S.S. CIGALE

Rough Sketch showing Drillings and Plates renewed Port Natal

September 1920.

PORT

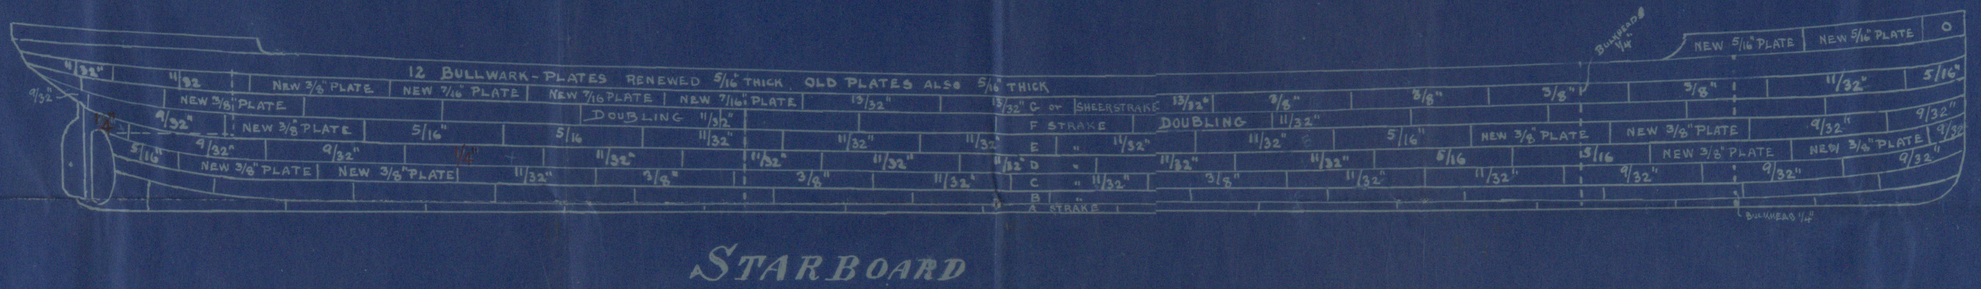
Nos 1 and 4 plates from aft in "D" strake on both sides (marked in red) are only 1/4" thick. These were in owing to the limited time allowed vessel on Dry-dock. The plates were thoroughly scaled & painted and are, I consider, quite good for 4 years. — The average thickness of the plates condemned in Sheer strake was 5/16". — The average thickness of other plates condemned in other strakes 3/16". — A number of the plates renewed here are over the necessary thickness, sufficient 5/16" plates not being obtainable.
